The failure of the National Park planning system at Cairn Gorm – the magic carpet construction

Construction of magic carpet 4th December – Photo Credit Alan Bratney

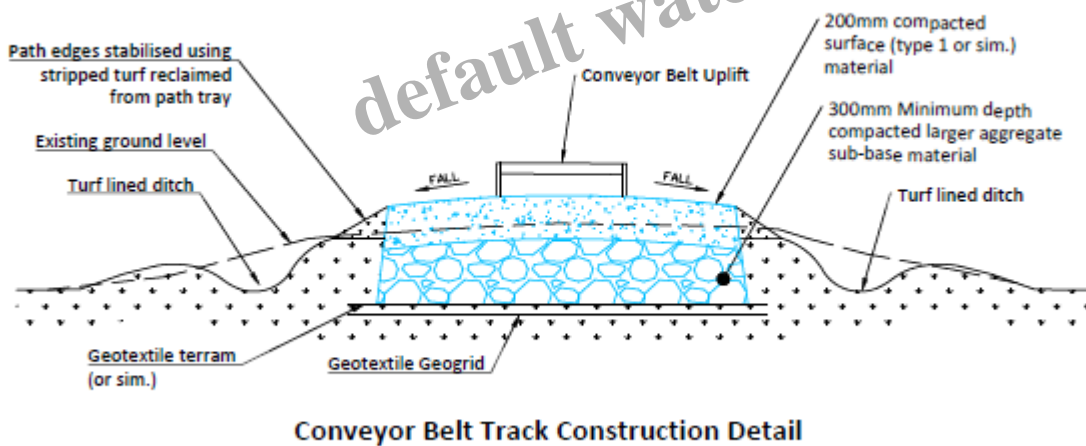
The work being undertaken to construct the lower of the two magic carpets bears no resemblance to that which was approved by the Cairngorm National Park Authority (CNPA) in May.

While it is difficult to estimate the exact width of the construction corridor from the photo, the vehicle tracks on the right suggest the corridor on the right of the conveyor is nearer four metres and more in places. It appears therefore the work McGowan is doing is not only contrary to their own Construction Method Statement, it is in breach of planning conditions.

Extract from plan for the 93m or lower belt, i.e. the one in the photo above.

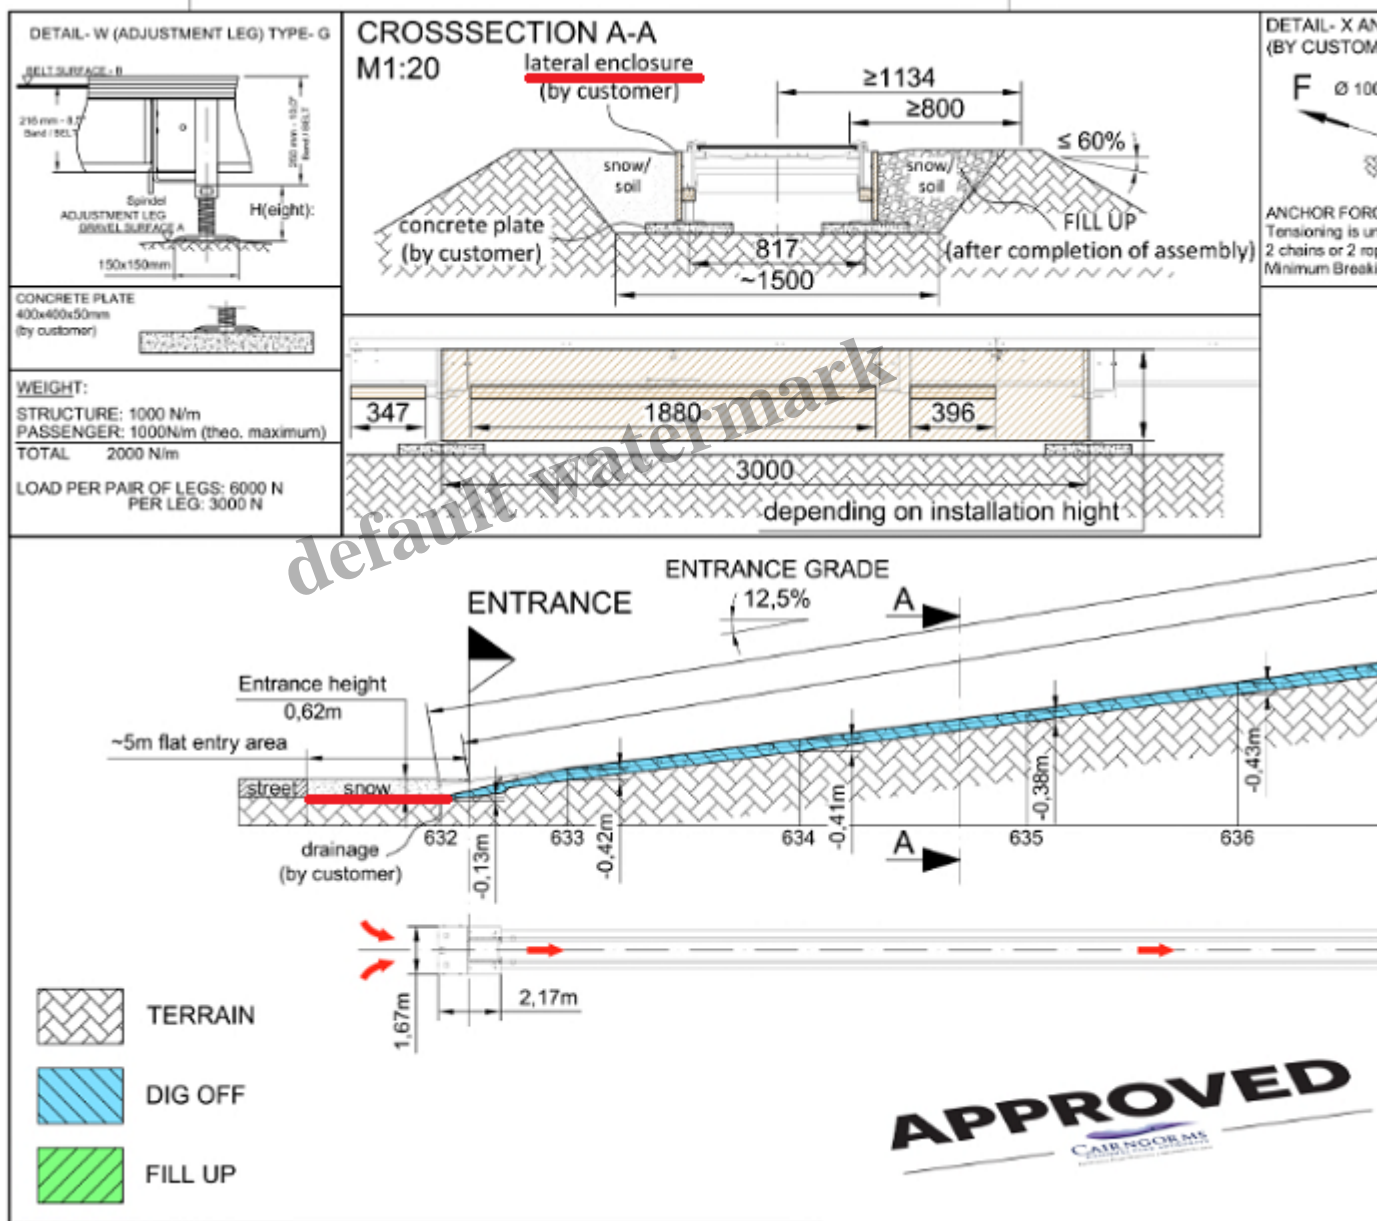
CMSL submitted plans showing the design of each magic carpet on 10th November, at least a week after construction had started. These were followed by five further documents showing the finishes on 22nd November. Unless the CNPA published these documents late, CMSL and McGowan appear to have commenced work on the magic carpet before the plans were approved.

The revised plans ([see here](#)) show a very different installation to the one originally approved, a magic carpet almost flush with the ground and bearing a reasonable resemblance to the work in progress:

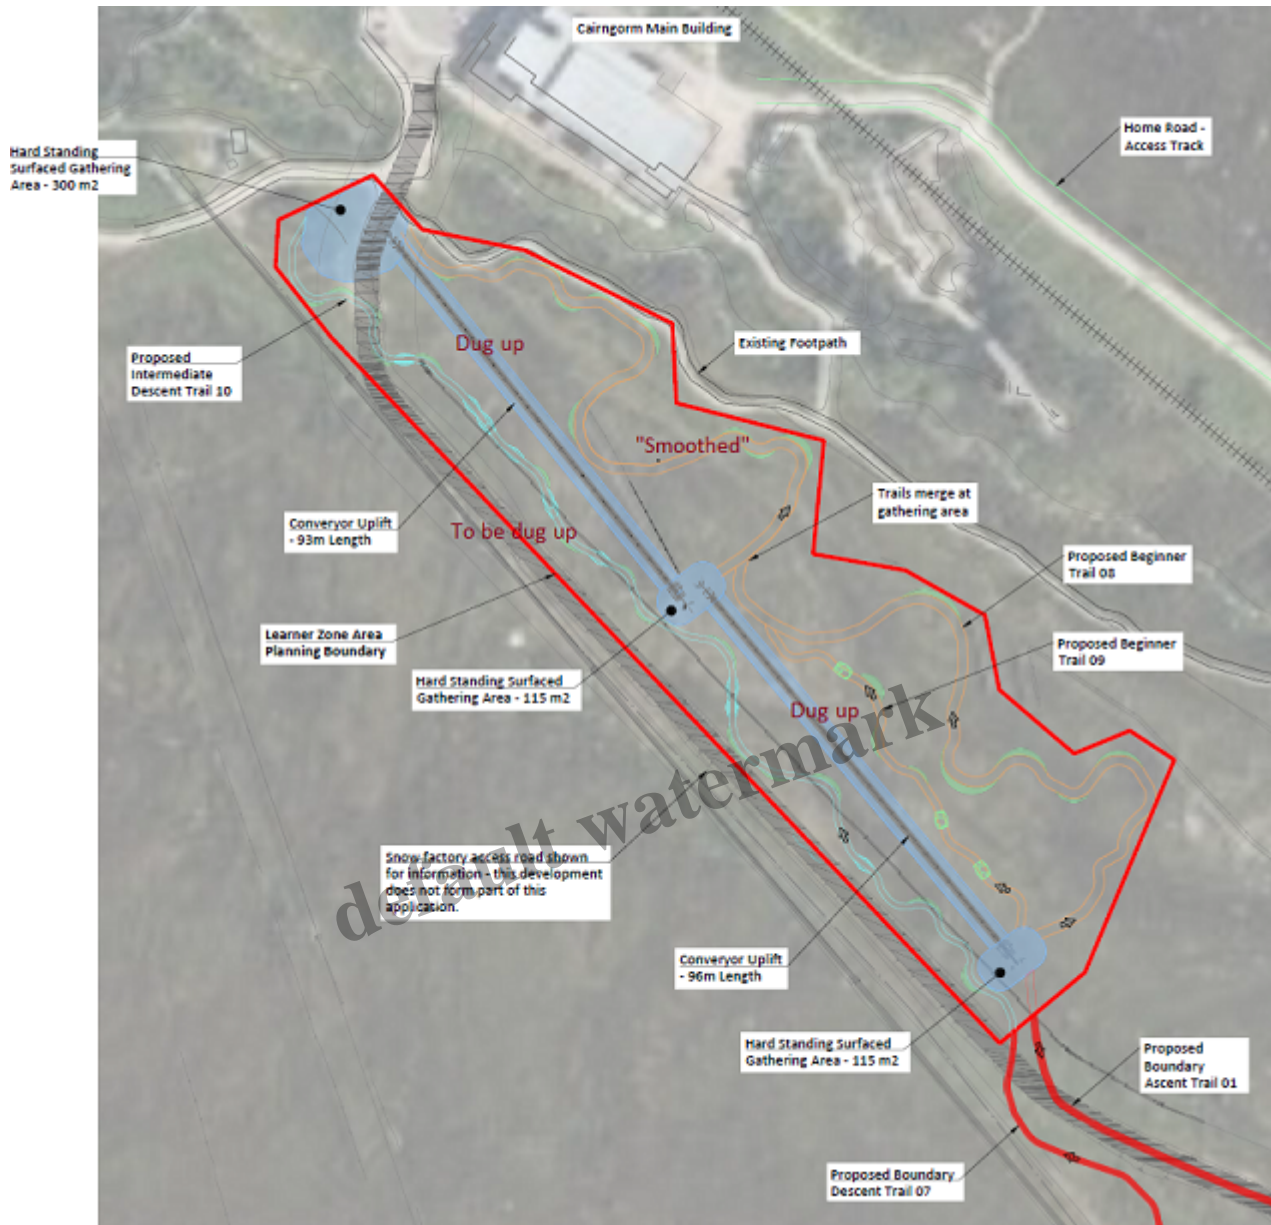
- The new plan shows the magic carpet sunk into the surrounding terrain (the hatched area). Had this been followed, only a narrow construction corridor and much smaller machinery would have been needed to install the carpet.
- In the plans the lateral enclosures of the space under the magic carpet (underlined in red) are vertical, whereas in the photo they are sloping at c45 degrees and half the space that the plans show would have been filled with soil/snow has been removed. That may not matter technically but is not in accordance with what the CNPA has now consented and means a bank will have to be constructed up the left hand side of the carpet, causing more ground disturbance.

A minor issue raised by the new plans is if terrain is to be brought up to the level of the magic carpet by packing down snow (also underlined in red), that will leave a step for children with mountain bikes to negotiate in summer on what is also supposed to be a family friendly uplift facility.

The most important point, however, is that none of the latest planning documents explain why such a broad construction corridor is required or have sought planning consent for this.
